Product Change Notification / NTDO-16ZPQO768

CCB 4969 Initial Notice: Qualification of A194 lead frame material and new DAP surface prep for USB5806, USB5807, USB5816, USB5826, USB5906, USB5916 and USB5926 device families in 100L VQFN (12 x 12 x 0.9mm) package.

Pre and Post Change Summary
PCN #: NTDO-16ZPQ0768

Pre Change

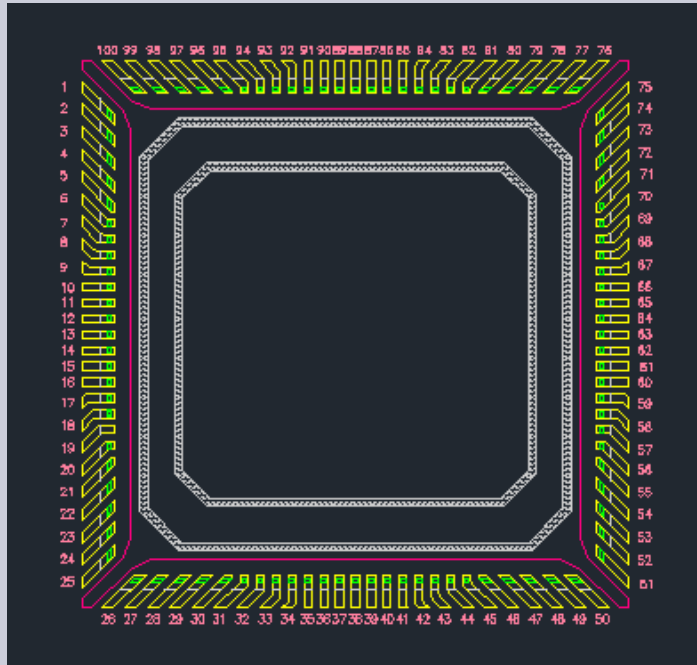
Leadframe Material	EFTEC64T
DAP Surface Prep	Double Ag ring plated
Lead Plating	Matte Tin

Post Change

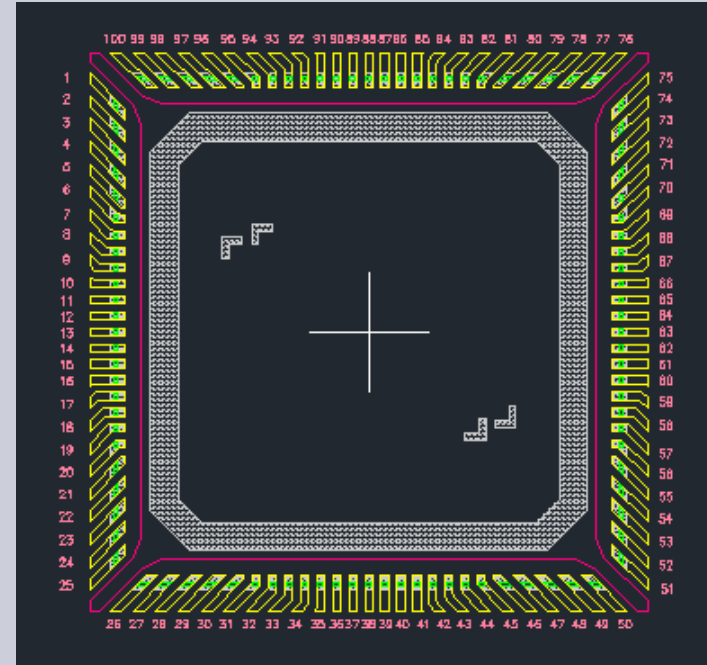
Material	A194
DAP Surface Prep	Single Ag ring plated
Lead Plating	Matte Tin
